Identified Gaps in the Provisions of the UN Regulation No. [157] (ALKS) (ECE/TRANS/WP.29/2020/81)

From the Approval Authority Standpoint

Note: This document is distributed as a background for the proposal
for a Supplement to UN Regulation No. [157] (ALKS) for information only.

Appendix 2 - Information document form for automated lane keeping systems to be provided by the manufacturer for the approval:

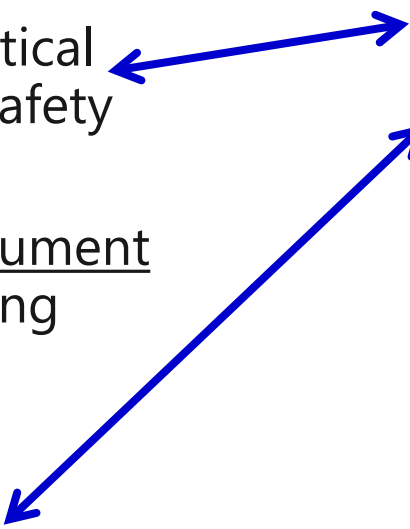
"7. Verification and test by the authorities..."

Section 7 is not logic as Appendix 2 is the form of the Information document for ALKS to be provided by a manufacturer before the approval process.

Note: If the communication from the Approval Authority to other Approval Authorities is needed, there should be a template for that communication and the list of items to be communicated.

In para. 4.2., could be a reference to Appendix 3.

In Annex 4, there is no reference to Appendix 3, but this reference should be.
In Annex 4, there should be a reference to Annex 5.

An Approval Authority has to have a complete picture of compliance assessment:

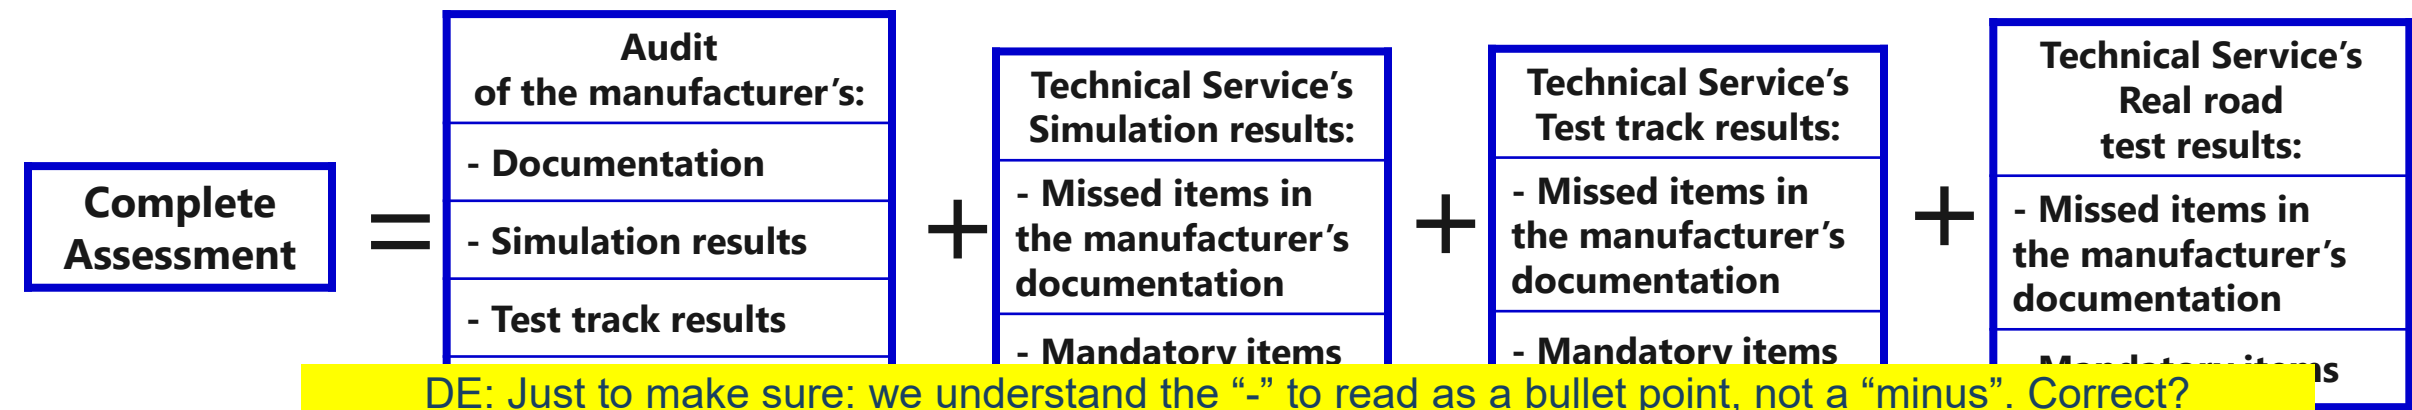
DE: Just to make sure: we understand the “-” to read as a bullet point, not a “minus”. Correct?
Yes, this summary seems to give the full picture. We are just wondering about the “Technical Service’s Simulation results”: where is this required in the ALKS Regulation? (Are we missing something...?) Isn’t simulation just part of the audit?

EC: I agree with Russia. We should define which items should be tested as a minimum. This requires more discussion

→ FR : this scheme is really understandable by TAA/TS, could be added in the Regulation ? Just some comments :

- Box 1 : simulation is not mandatory but optional
- Box 2 : not a dedicated box but an evaluation under box 1 if simulations are provided
